LIGO PROJECT		designed for	R.De Salvo
		draw. by	G. Gennaro-PROMECC
		date	26-12-04
title		LIGO-D051103-05-D	
HAM-OPTICAL BENCH		scale	1/6
SECTION E-E			A 1

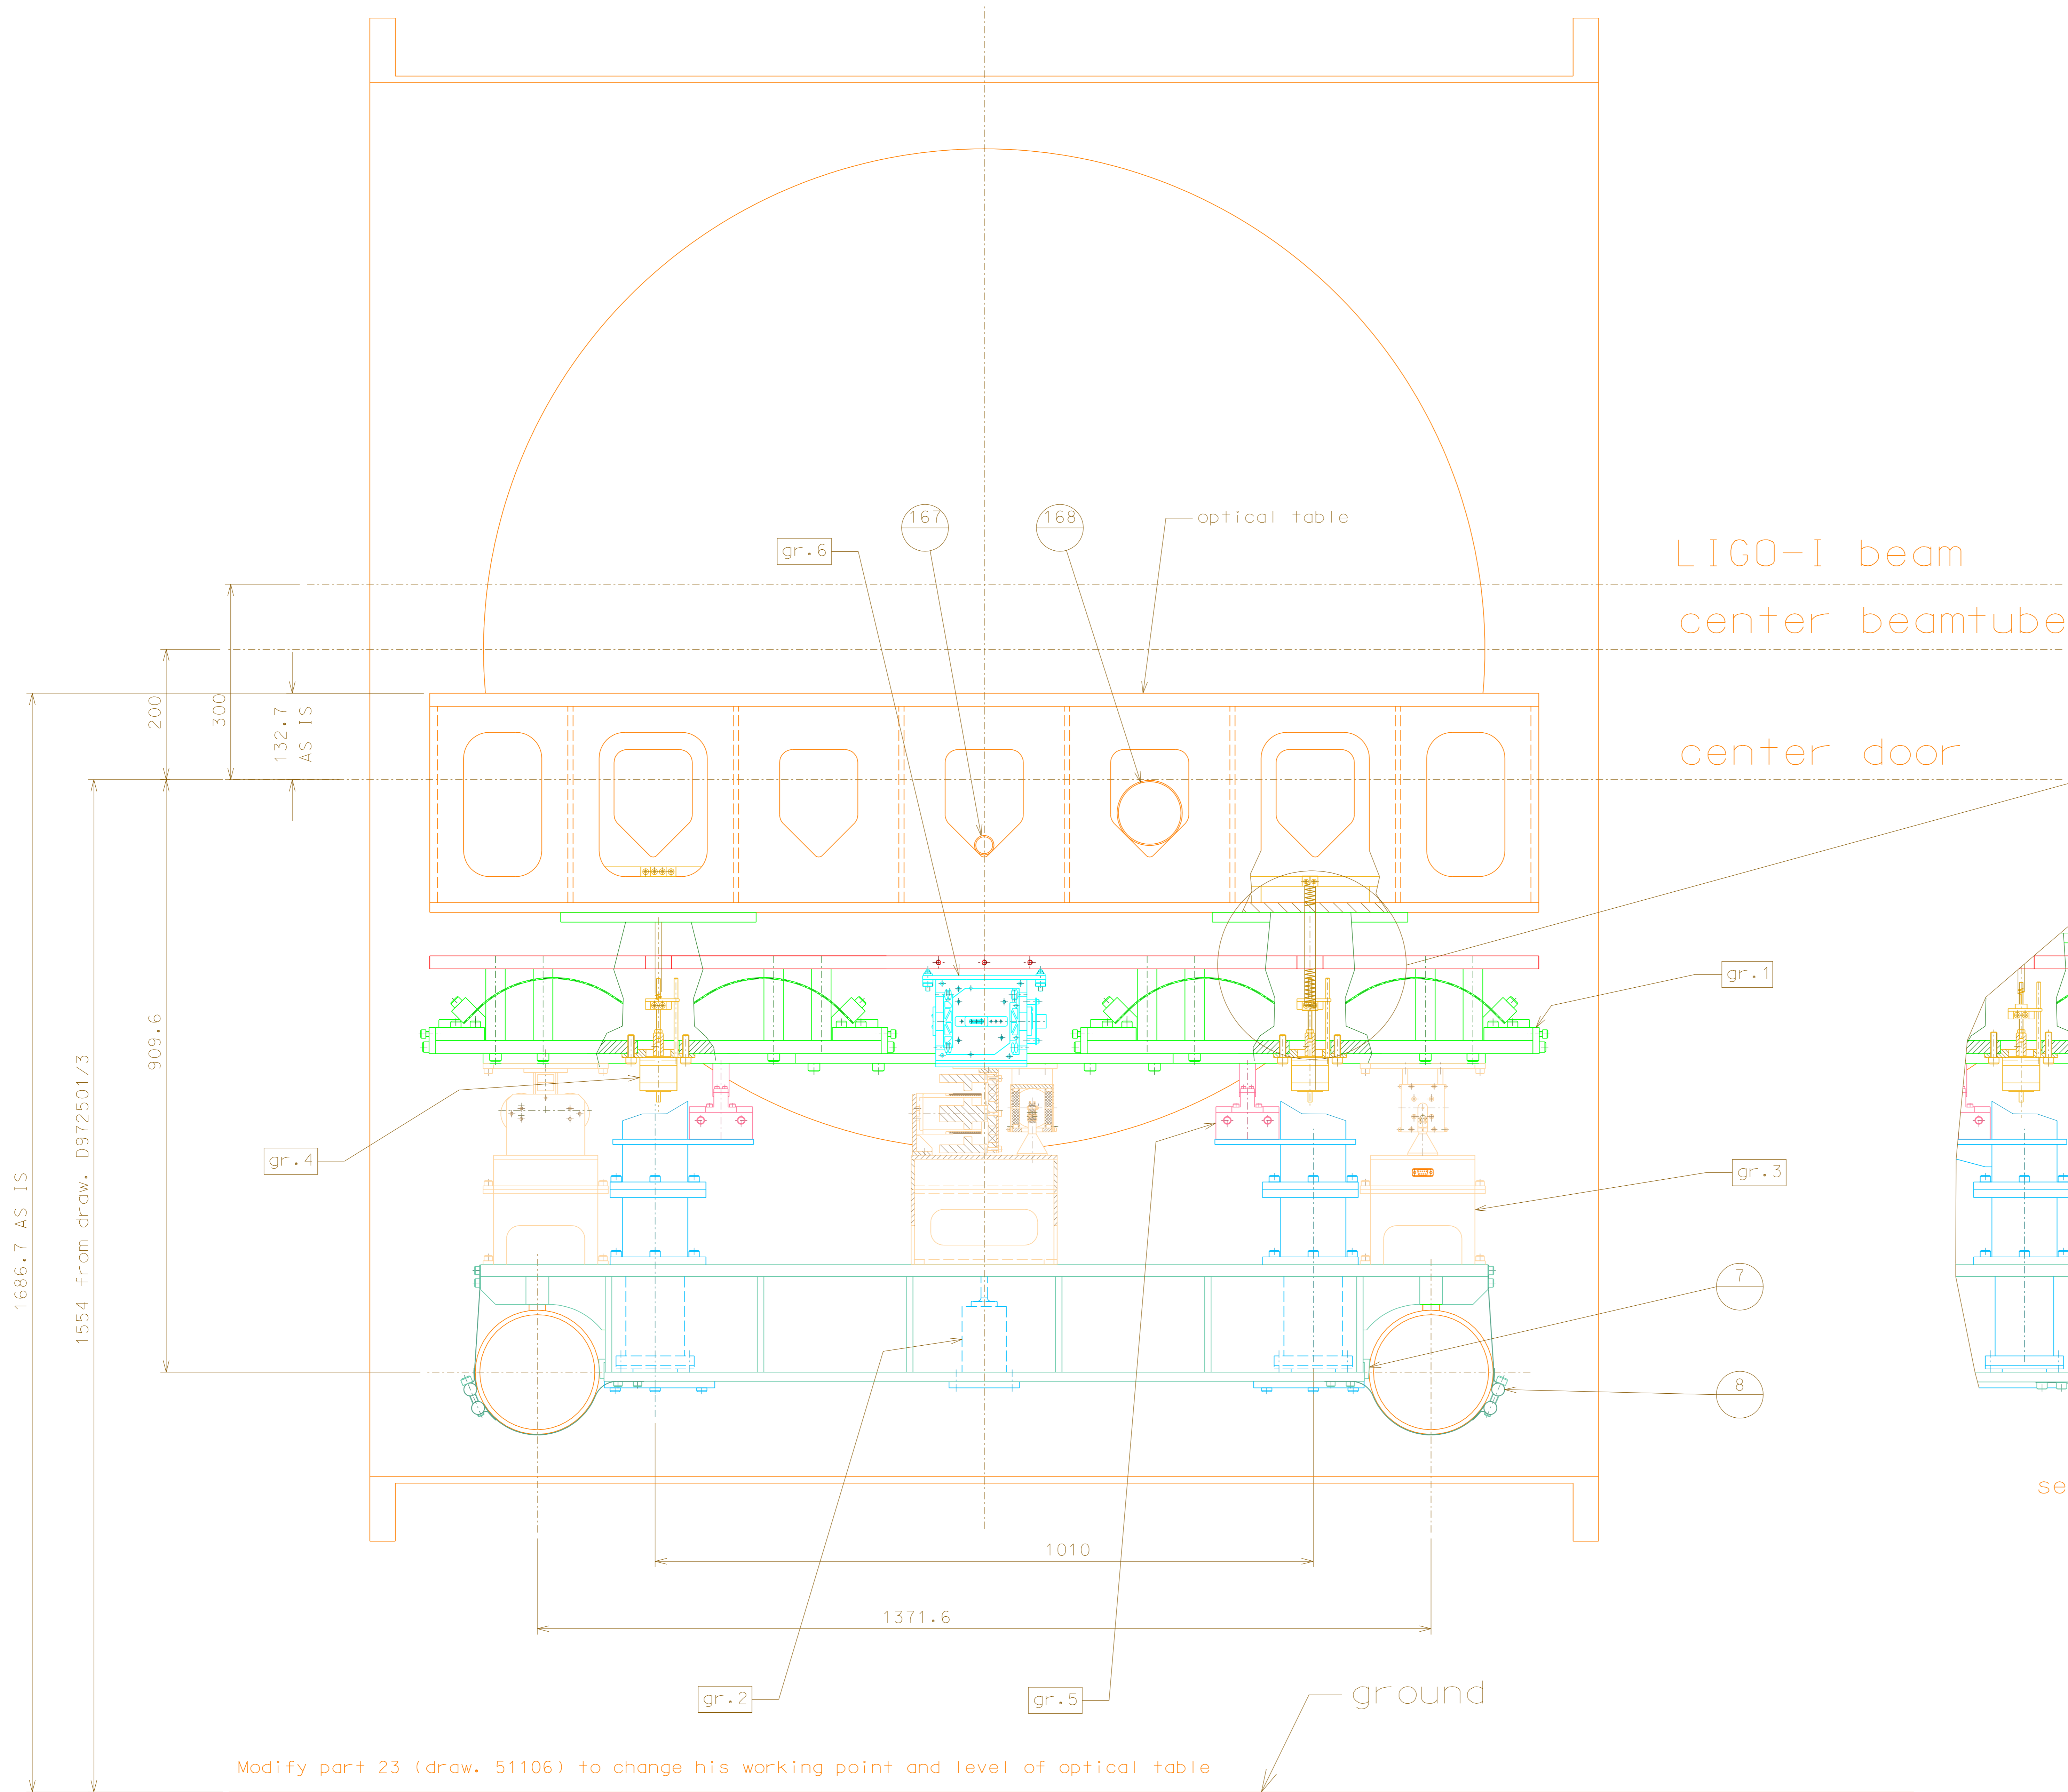
Modify part 23 (draw. 51106) to change his working point and level of optical table
